# APR1400 Design Certification Review I&C Topics

**KEPCO/KHNP**  
**August 12-13, 2015**

DCD Tier 2 Fig. 7.3-5 ESFAS Functional Logic (CSAS)

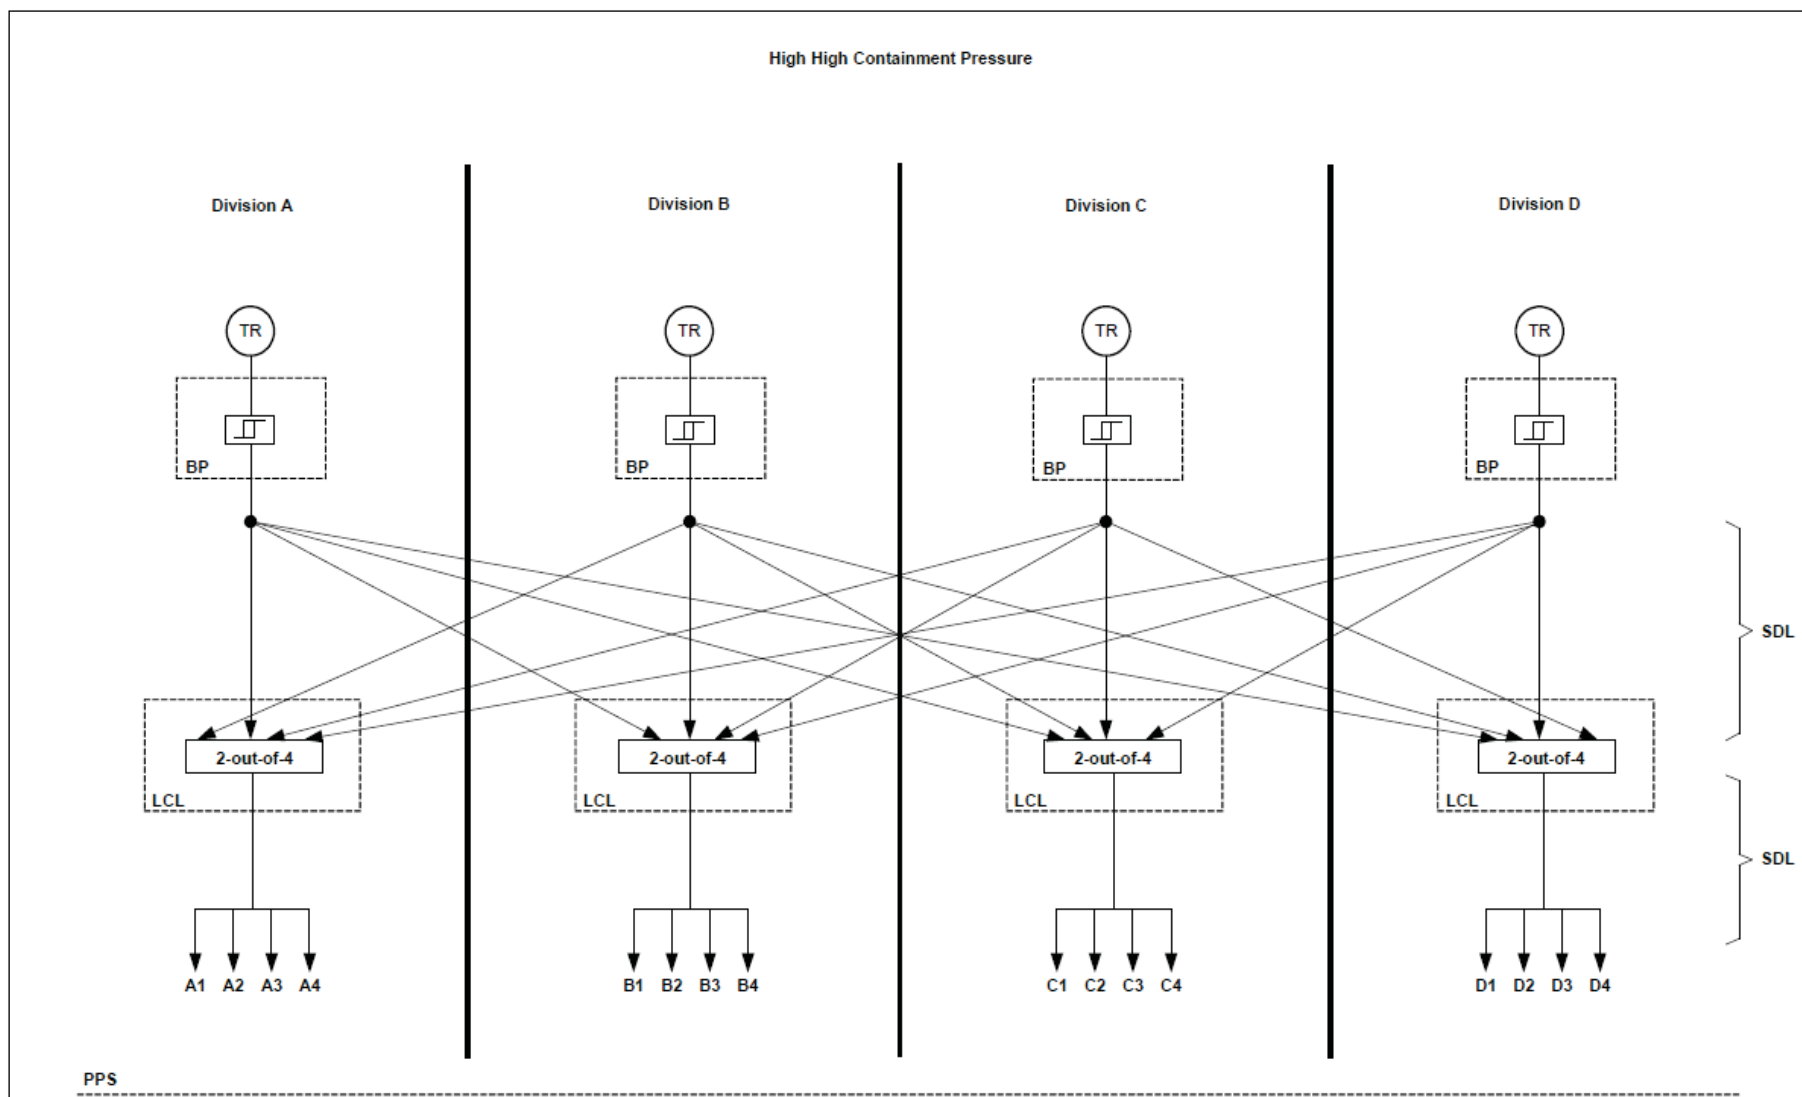
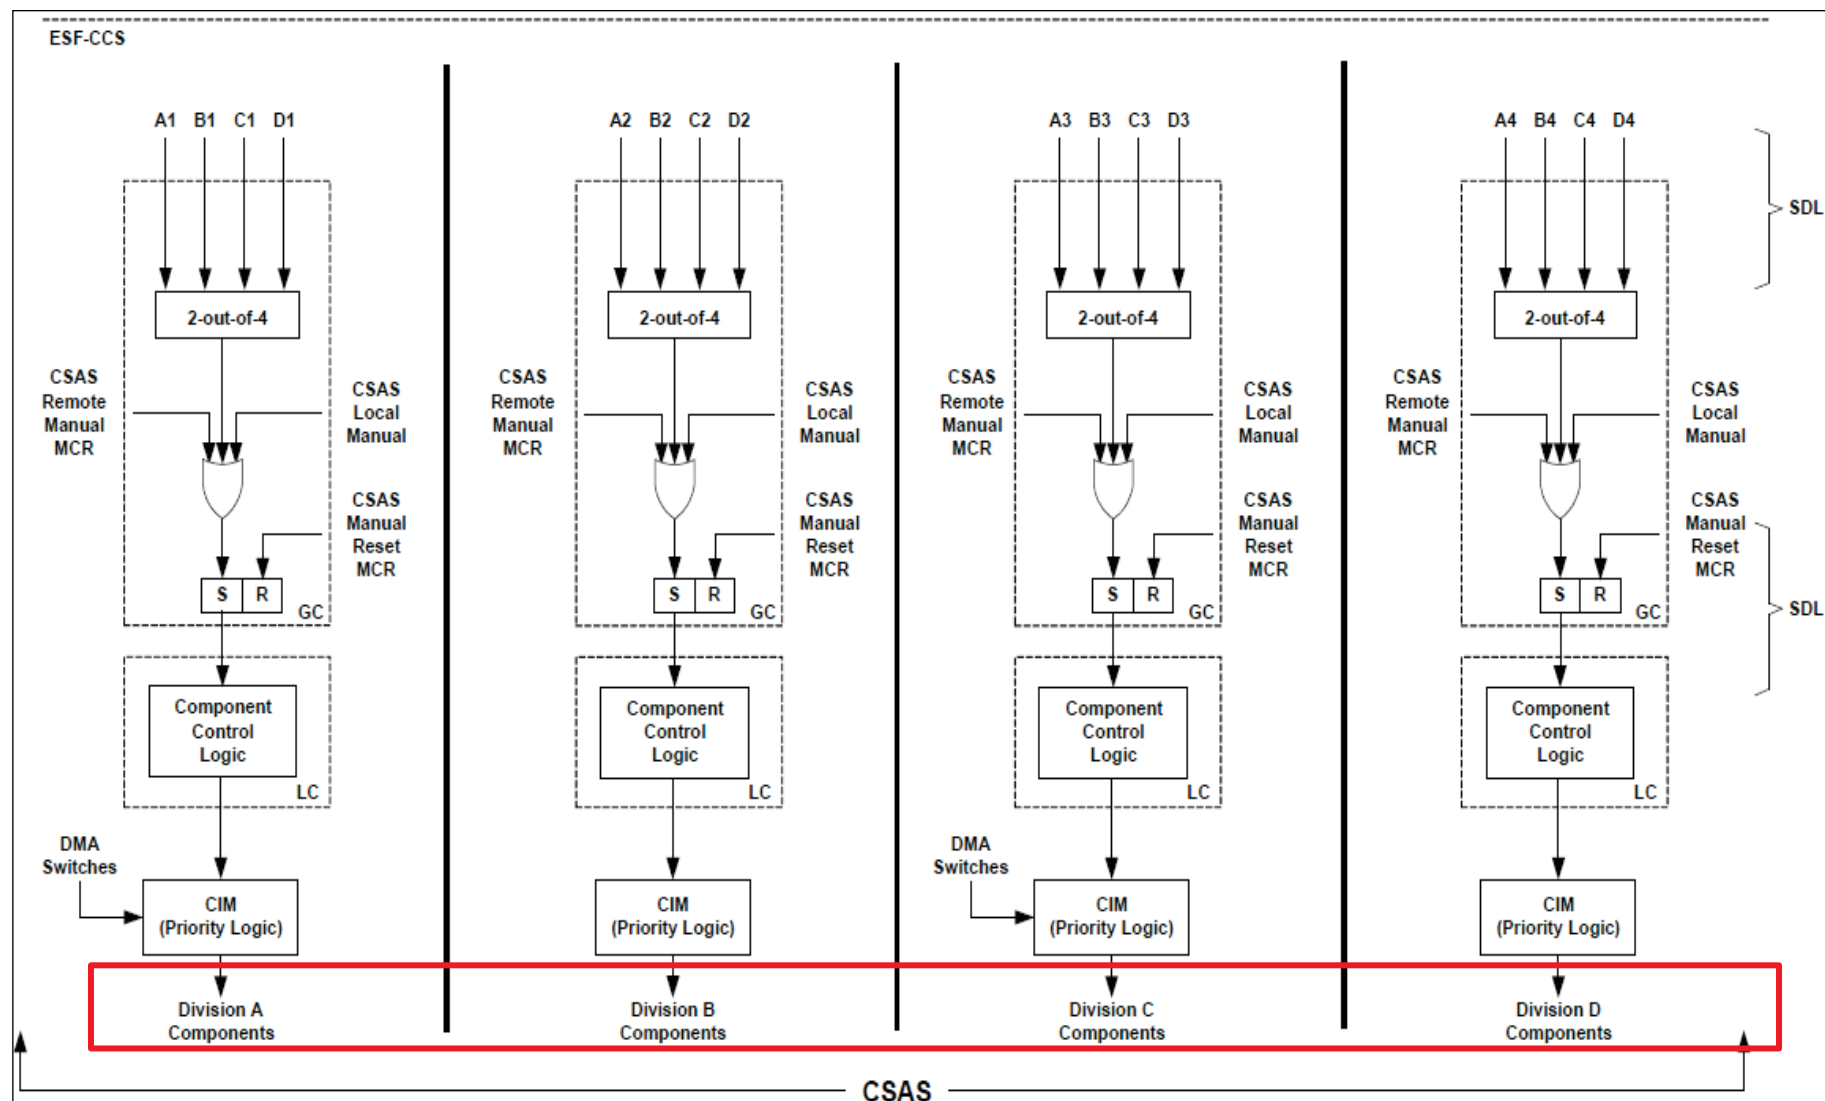
*The containment spray actuation signal (CSAS) is used to actuate the containment spray system (CSS). The logic diagram for CSAS in Figure 7.3-5 in DCD Tier 2 shows four divisions. However, there are only two containment spray pumps. How is the control logic for the two spray pumps implemented?*

- The containment spray actuation signal (CSAS) initiation signal is generated from all four PPS divisions A, B, C, and D, and the initiation signal is transmitted to the group controllers (GCs) in all four ESF-CCS divisions as shown in Figure 7.3-5 of DCD Tier 2.
- The GCs in each ESF-CCS division perform a selective 2-out-of-4 coincidence logic based on the CSAS initiation signal and transmit the actuation signal to the loop controllers (LCs).
- The outputs of the LC in ESF-CCS divisions A, B, C, and D are then transmitted via the component interface module (CIM) to the division A, B, C, and D components, respectively. This is shown in Figure 7.3-5 of DCD Tier 2 and described in Subsection 7.3.1.7 of DCD Tier 2: *“Each ESF-CCS division actuates the ESF components assigned in that division.”*

- As described in Subsection 6.5.2.1 of DCD Tier 2, the containment spray system (CSS) is designed to have two independent divisions, each of which contains one containment spray pump.
- One containment spray pump is actuated by the CSAS from ESF-CCS division C, while the other containment spray pump is actuated by the CSAS from ESF-CCS division D.
- The CSAS from ESF-CCS divisions A and B each actuates a shutdown cooling pump when containment spray pumps are not available to actuate.

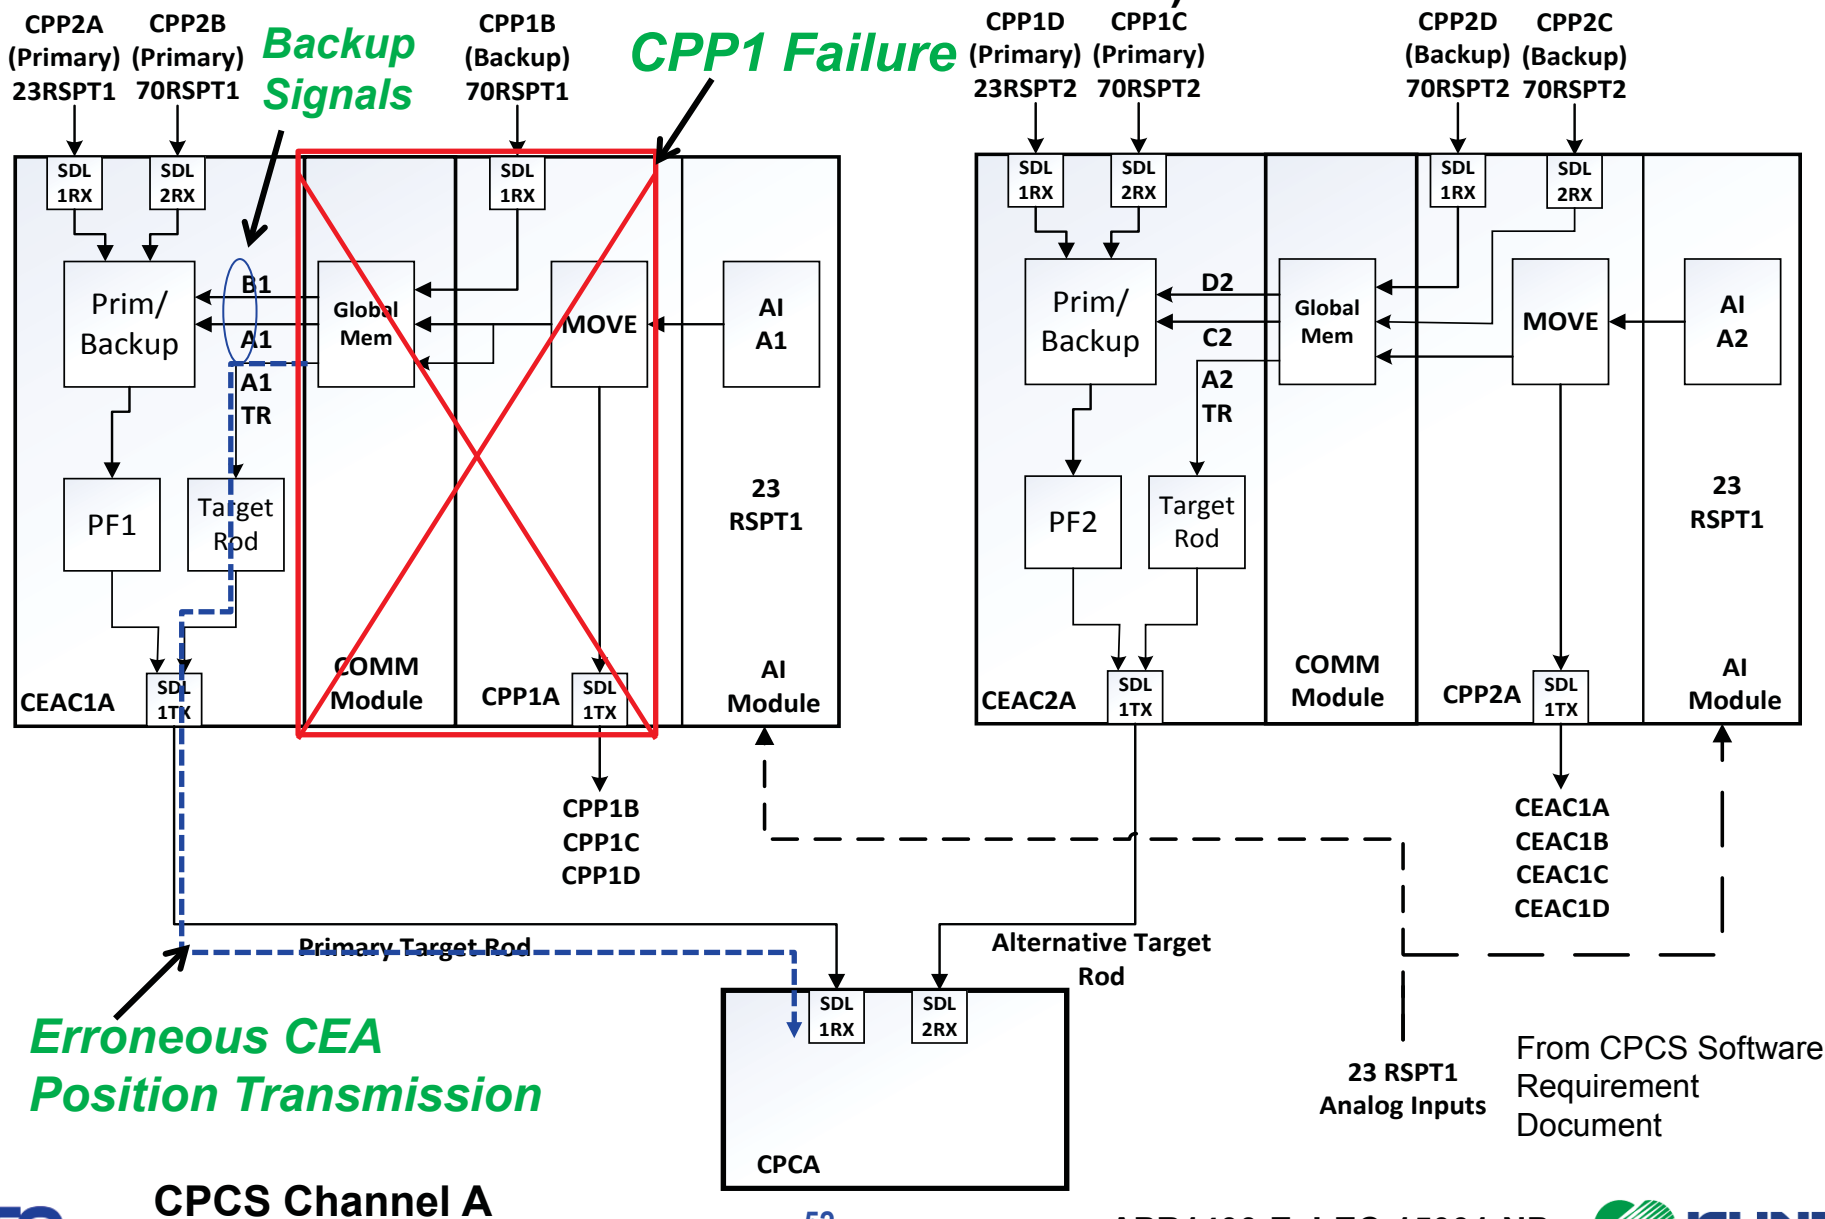
*For the APR1400 FSAR, Tier 2, Revision 0, Table 7.2-7, “Failure Mode and Effects Analysis for the Plant Protection System,” single failure entry item 2-14, b), provide detailed design descriptions that would explain the failure terms:*

*Provide detailed design descriptions that describe and define the failure terms used of software malfunction, erroneous CEA position, erroneous CEA indication, and improper CEA position. In addition, describe how, upon receiving improper CEA position, a CPC channel would become inoperable and the RPS logic would change to a 2-out-of-2 coincidence logic.*

- **Unrecognized software malfunctions**
  - Software failure which can not be detected by system and application diagnostics
- **Erroneous control element assembly (CEA) position transmission and indication**
  - The CEA position processor reads the CEA positions and provides these values to the CEA calculator (CEAC) for calculation and to the OM and MTP for display.
  - Erroneous CEA position transmission means providing CEA values which are different from reading values from AI modules to the CPP, CEAC, and CPC processors.
  - Erroneous CEA indication means providing CEA values which are different from reading values from AI modules to the OM and MTP.
- **Improper CEA position**
  - Erroneous CEA positions which can not generate the DNBR/LPD trip

Fig. 4-8, Safety I&C System TeR (simplified)

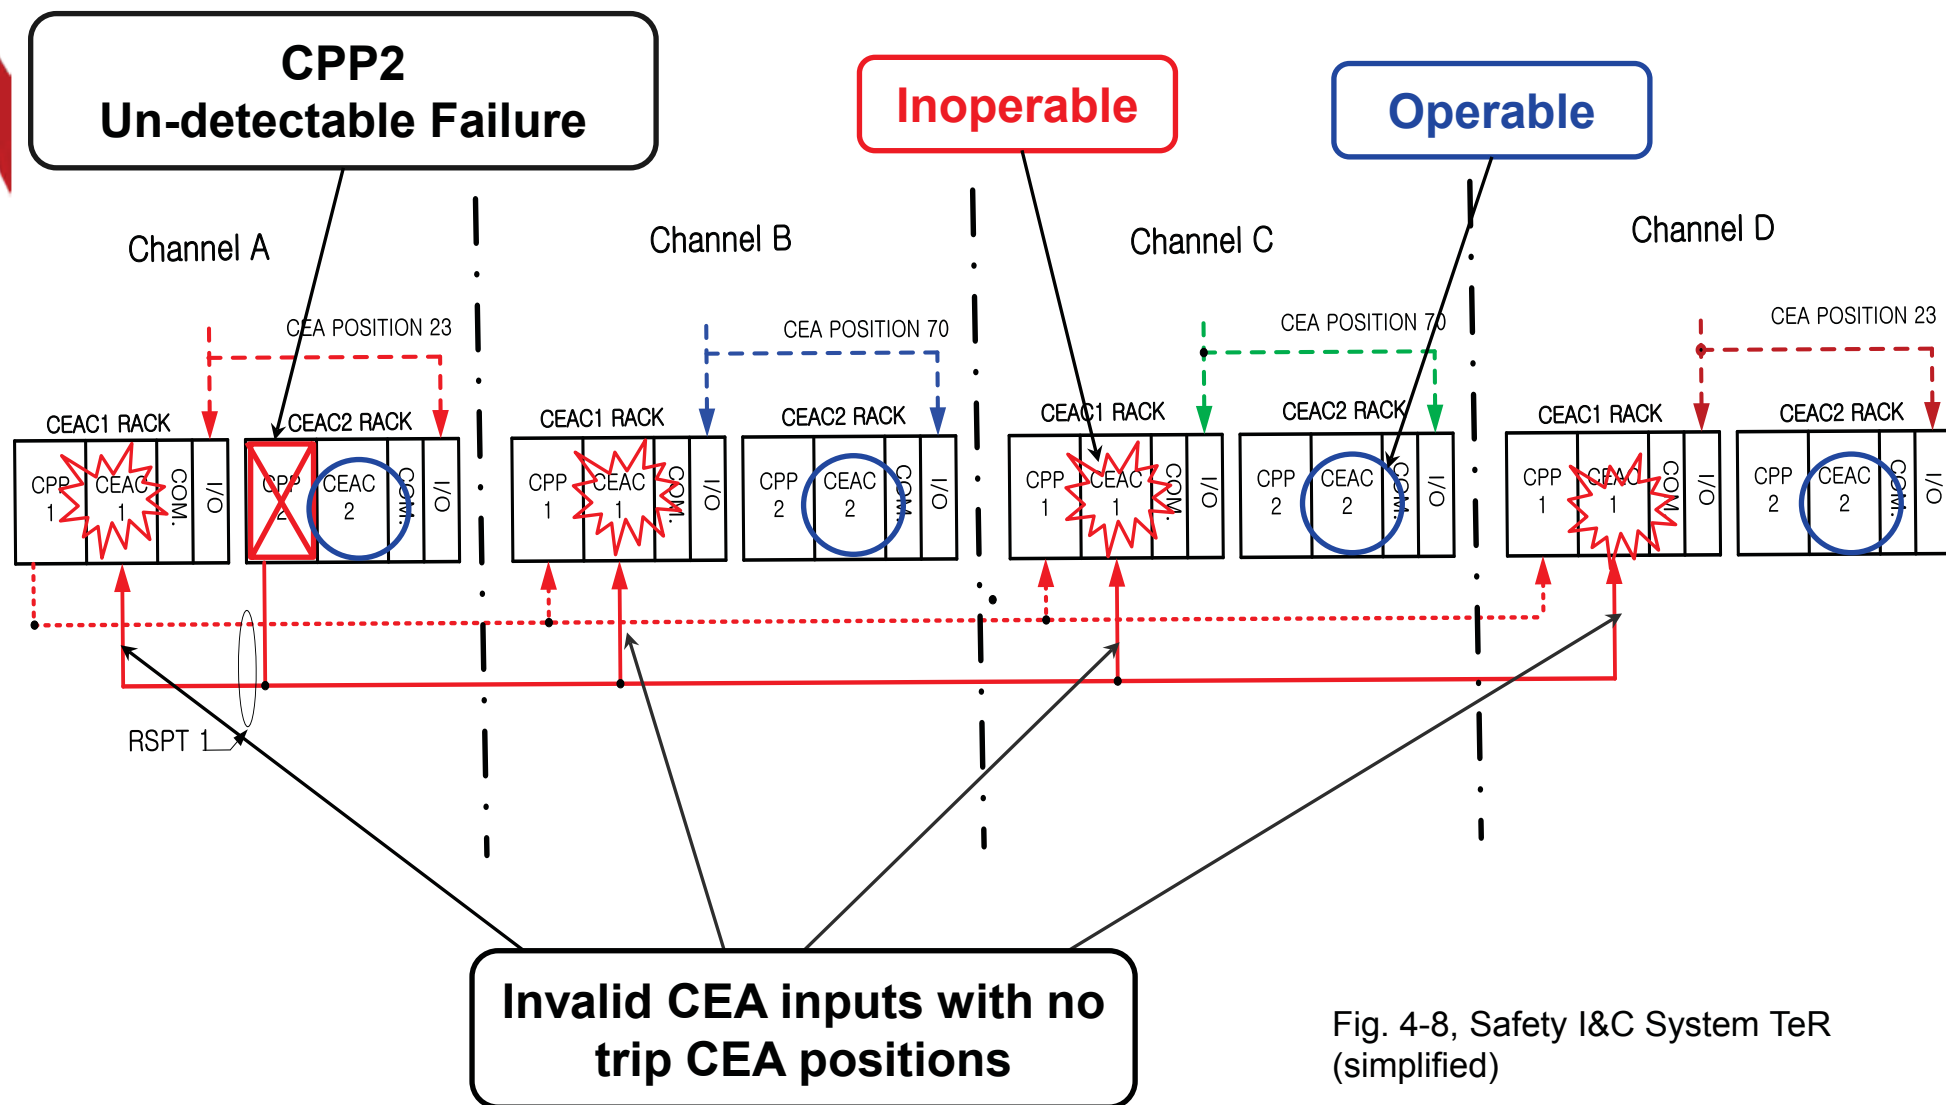
*If a CEAC receives an invalid CEA position, does that make the CEAC inoperable?*

- Tier 2 Table 7.2-7 (FMEA) to be revised
  - This is the CEAC1 inoperable case by invalid CEA position.
  - Failure mode is erroneous CEA position transmitted by operating CPP2.
  - A new item will be added in the FMEA Table as follows.

No.	Name	Failure Mode	Cause	Symptoms and Local Effects Including Dependent Failures	Method of Detection	Inherent Compensating Provision	Effect Upon PPS	Remarks and Other Effects
Later	CEA Position Processor 2 in Channels A or B. Processor and/ or communication section.	b) ON; <b>Erroneous CEA position transmitted</b>	<b>Un-recognized hardware or software malfunction</b>	Failure to provide proper primary source of CEA position in CEAC 1 in all channels. Possible failure of alternative source of target CEA position transmission in channel of origin	Possible <b>erroneous non-target CEA position indication. Possible difference between PF of CEAC1 and CEAC2</b> If problem is occurred due to processor failure, this is detected by on line diagnostics and a CPP Trouble/CPP WDT time out.	CPP2 is primary source for CEAC 1 position indication, and is normally selected. If non-target CEA position may be improper in one CPC channel, CEAC2 is redundancy.  CPP2 is alternative source of Target CEA position.	None. If <b>non-target CEA position is improper</b> , CEAC1s in all channel are inoperable, and CEAC2s are available in four channels. <b>RPS logic is in 2-out-of-3 coincidence logic.</b>	Operation with a single failed CEAC in one or more channels addressed in LCO 3.3.3. After on-line diagnostic function is performed and the problem within CEAC module is identified, CEAC fail condition is generated.
